# APU EXHAUST DUCT BRACKET

REDUCES FATIGUE CRACKING

LOCKHEED MARTIN

APU Exhaust Duct

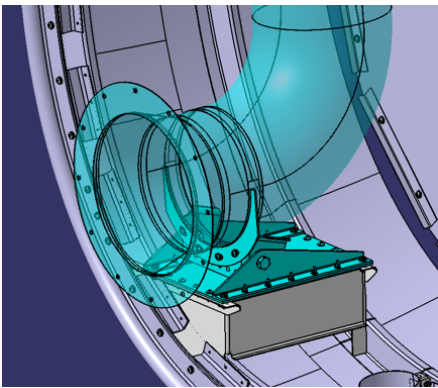
Lockheed Martin is continuously improving production C-130J aircraft based on field experience and has developed an improved APU Exhaust Duct Bracket. As a result, this improved bracket is currently installed on production aircraft and significantly reduces the instances of fatigue cracking.

The improved APU exhaust duct bracket modifies the duct and support structure to eliminate premature cracking and failure of the duct and duct bracket. The kit includes the modified duct and support structure to replace the original parts and increase the service life of those components and reduce downtime.

The improved APU exhaust duct bracket does not require additional modifications of structure underneath the fire shield and can be installed by the operator at home base.

**APU Exhaust Duct Bracket Kit:** The kit includes the new duct, bracket and all required installation hardware plus instructions for removing the existing equipment and installing the new parts.
